STAFF RECOMMENDATION
1910 19th Avenue South
October 17, 2018

Application: New Construction—Outbuilding (Detached Accessory Dwelling Unit)
District: Belmont-Hillsboro Neighborhood Conservation Zoning Overlay
Council District: 18
Map and Parcel Number: 10412018700
Applicant: Mitch Hodge
Project Lead: Melissa Sajid; melissa.sajid@nashville.gov

Description of Project: The applicant proposes to construct lateral and rooftop additions to the existing outbuilding and convert it to a detached accessory dwelling unit.

Figure 1: 1910 19th Avenue South

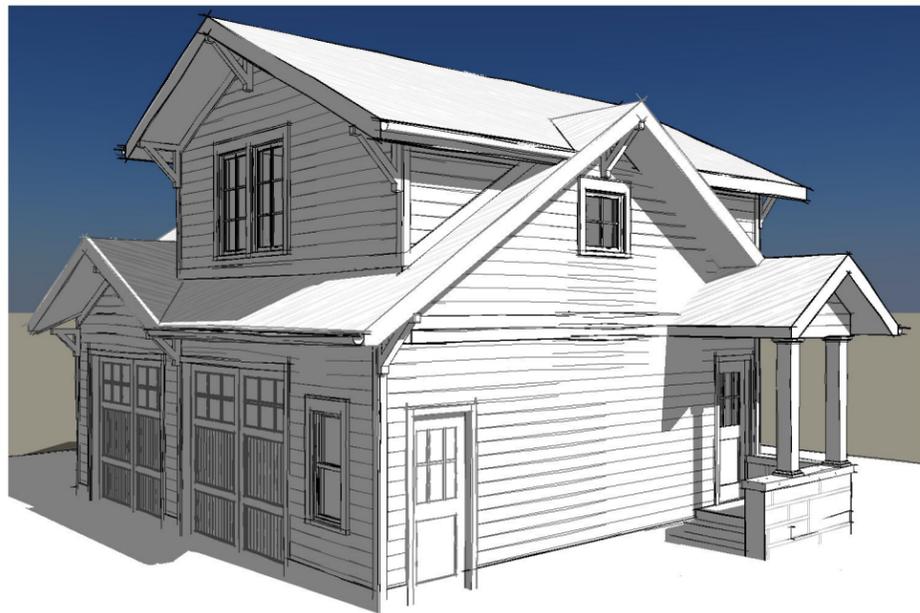
Background: The house located at 1910 19th Avenue South was built circa 1928 and contributes to the character of the Belmont-Hillsboro district (Figure 1).

Figure 2: Existing outbuilding

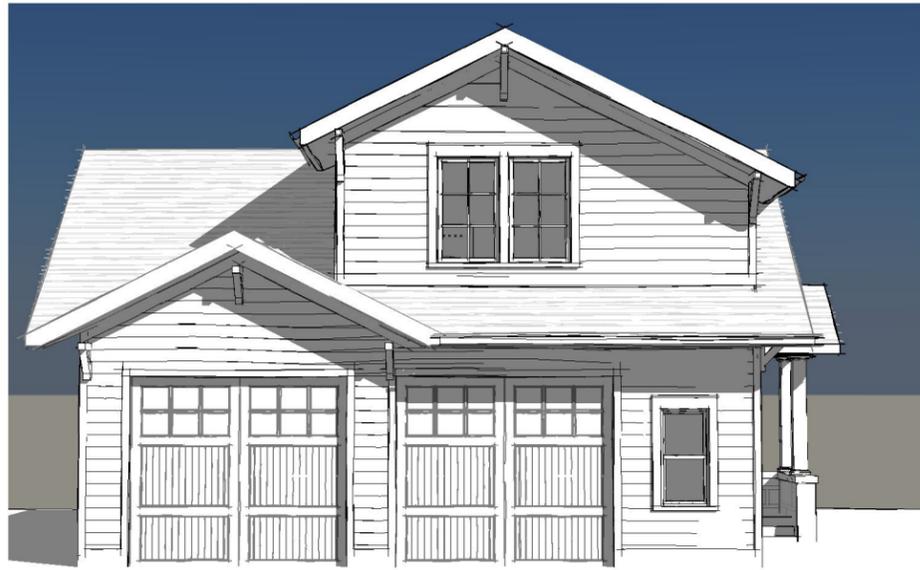
Analysis and Findings: The applicant proposes to construct lateral and rooftop additions to the existing single-story outbuilding (Figure 2) and to convert the outbuilding to a detached accessory dwelling unit. MHZC permitted the existing outbuilding in 2006 (permit # 2006-168). The plan includes the addition of a covered stoop on the right side façade of the outbuilding. Due to the extent of the alterations and the proposed change of use, staff reviewed it as if it were a request for a new outbuilding.

1 SITE - 1910 19TH AVE SOUTH
A-1 1" = 20'-0"

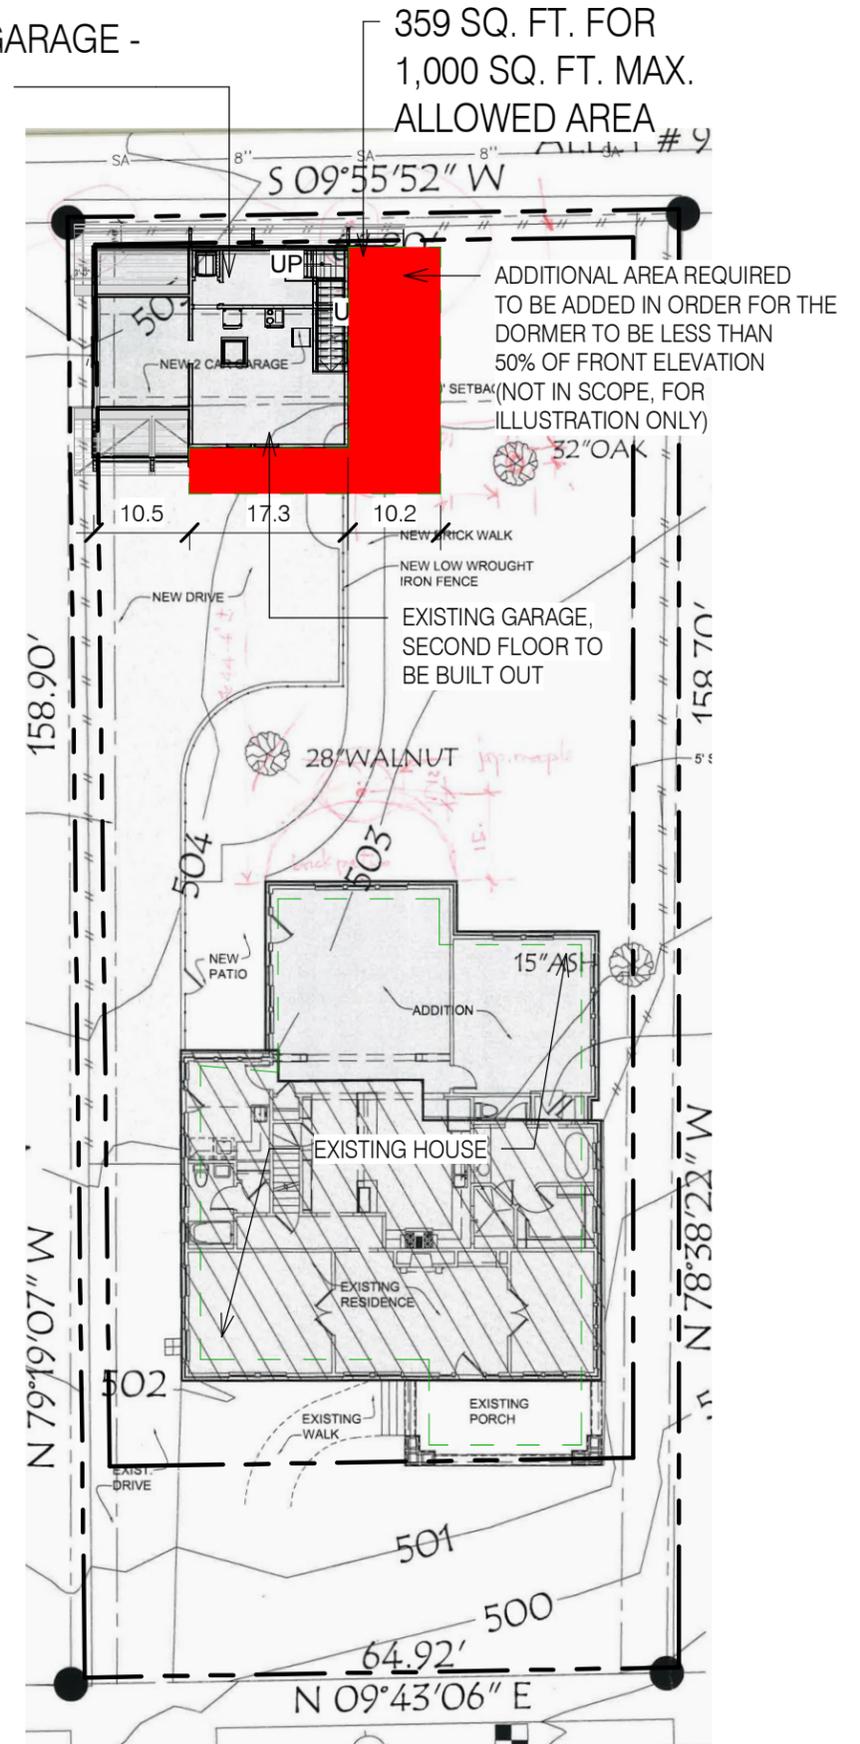
The site plan includes an outline of an addition to the footprint of the existing outbuilding, but that is not proposed with this application; therefore staff recommends obtaining a site plan that accurately portrays just what is being requested. Also, the left side

The site plan does not indicate that the footprint will be increased, but the elevations include a covered side stoop with posts that go to the ground. In the past, the Commission has included this type of covered space in the overall footprint. The covering is approximately four feet, six inches (4'-6") by eight feet (8'), which would add thirty-six square feet (36 sq. ft.) to the footprint.

A-2

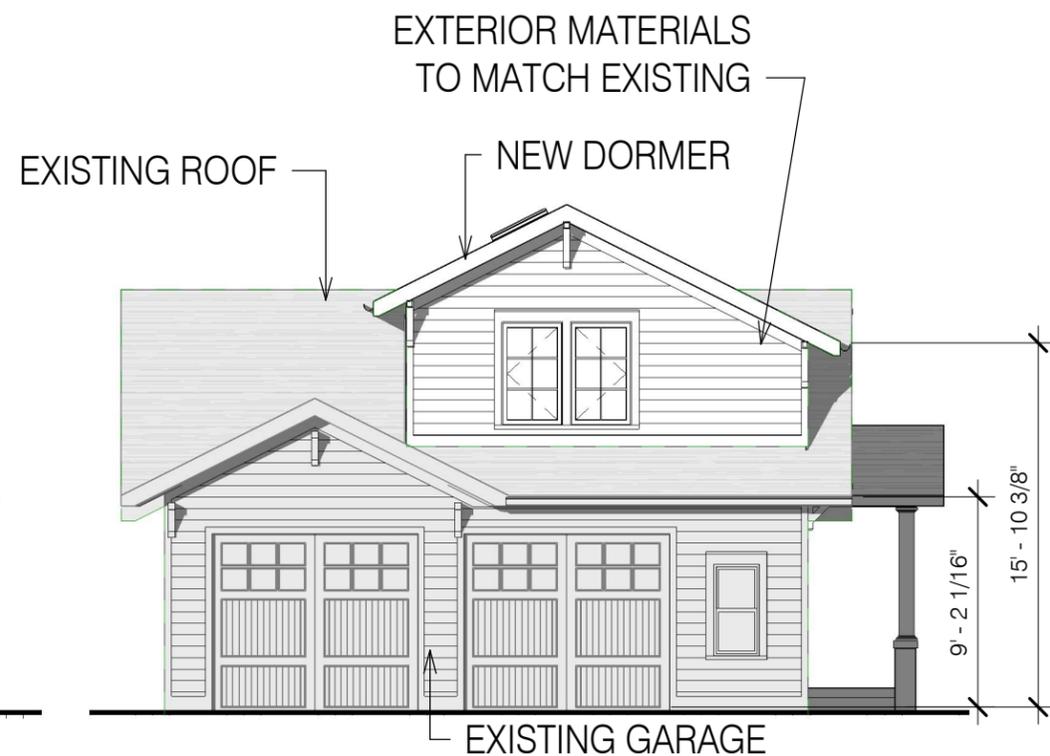
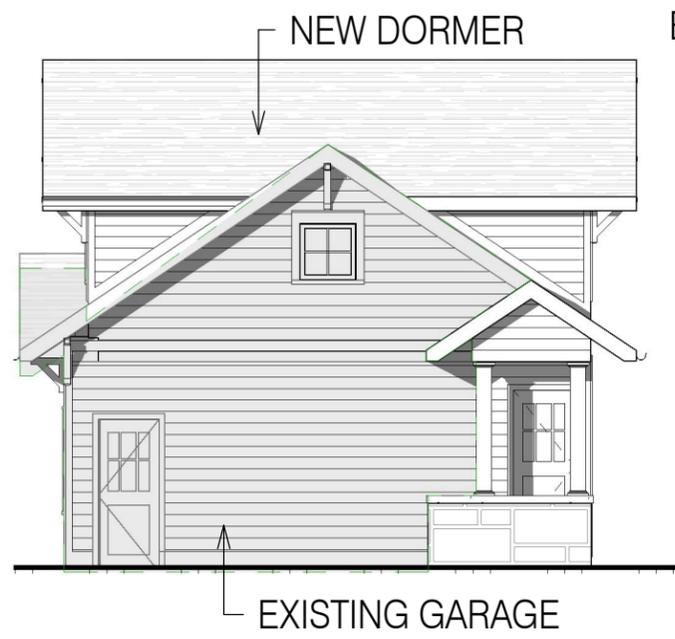
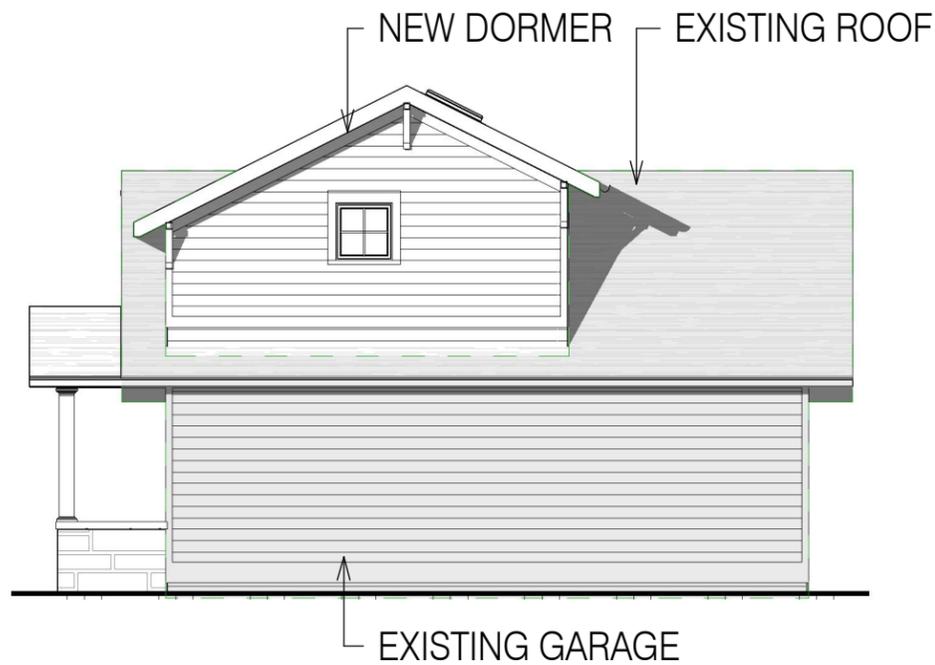
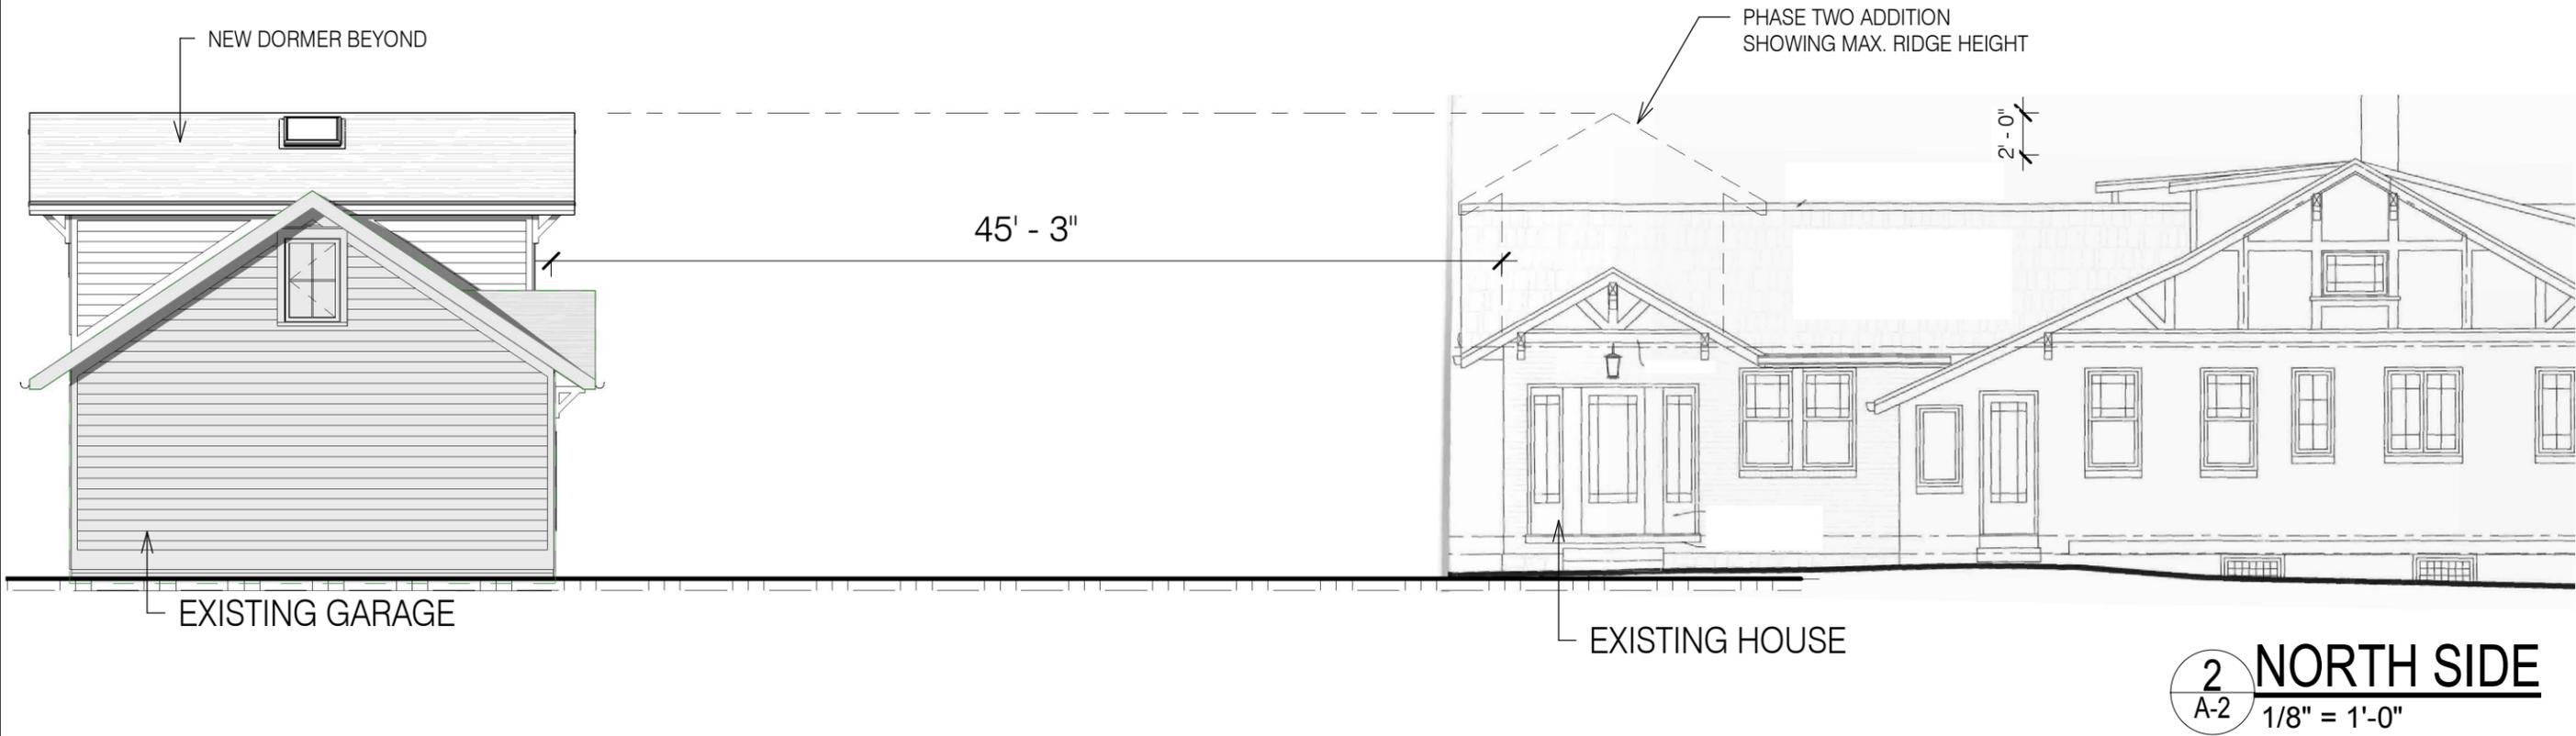
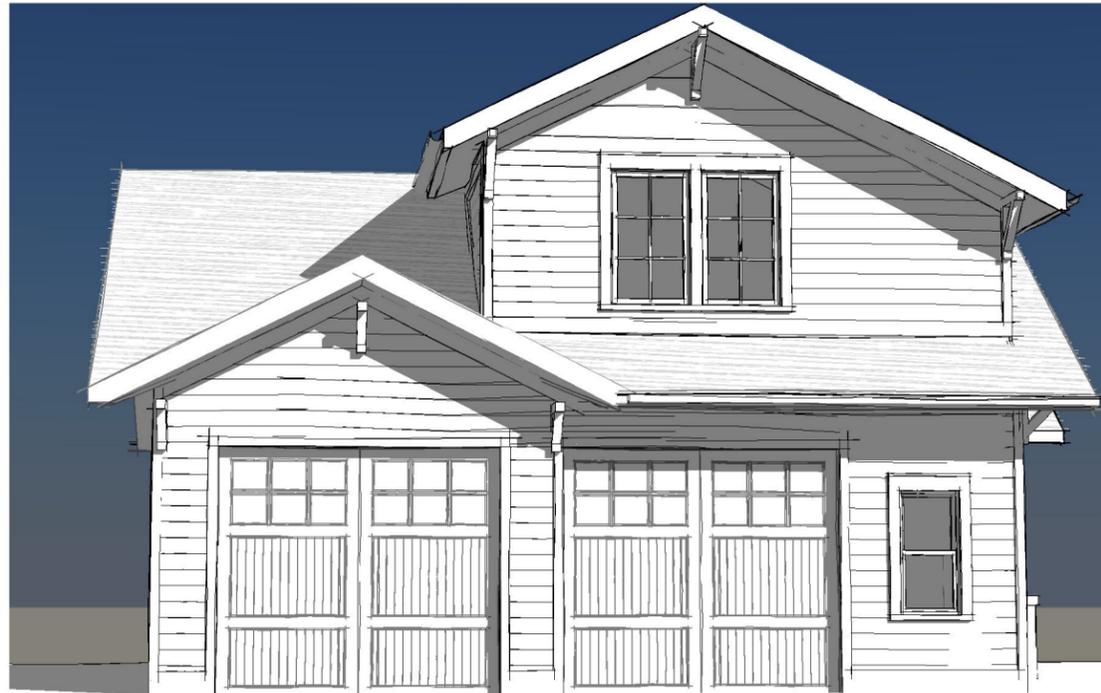
The applicant also proposes to add living area above the garage, and the plan labels the proposed addition as dormers; however, because what is labeled as dormer does not just project out from the roof but extends above the existing roof, staff reviewed the proposal as a new cross-gable roof form for the existing outbuilding. With the proposed rooftop addition, the overall height will be taller than that of the existing house, which exceeds the maximum allowed by the design guidelines and the eave height will exceed the maximum allowed by the design guidelines. Staff recommends that the overall height of the addition be reduced so that it does not exceed twenty feet (20'), which is the height of the historic house as measured from grade and that the eave height not exceed ten feet (10').

The proposed roof top addition does not meet the design guidelines for roof form as it creates an asymmetrical cross-gable that is not typical in the district and therefore does not meet Section II.B.i.1.

The existing outbuilding is single-story and cross-gabled like the historic house. The proposed roof top addition does not meet the design guidelines as it creates an asymmetrical cross-gable that is not typical in the district and therefore does not meet Section II.B.i.1. There are multiple options available for additions where the roof form would meet the design guidelines. One would be to add true dormers to the existing roof form that meet all the design guidelines. Another option would be to create a symmetrical cross gable with a continuous eave, rather than two different eave heights. However, the proposed design does not meet Section II.B.i.1. of the design guidelines.

The materials for the addition are not labeled on the plans so are unknown at this time. Staff finds that with final review of the cladding, roofing, trim, windows, door, porch roof, porch floor, porch posts, and porch base that the outbuilding meets Section II.B.i.1 in terms of materials.

1. The overall height of the DADU shall not exceed the height of the house and the eave height shall not exceed 10' from grade;
2. The roof form shall be appropriate for the district; and
3. Staff approve the final selections of the cladding, roofing, trim, windows, door, porch roof, porch floor, porch posts, and porch base prior to purchase and installation.
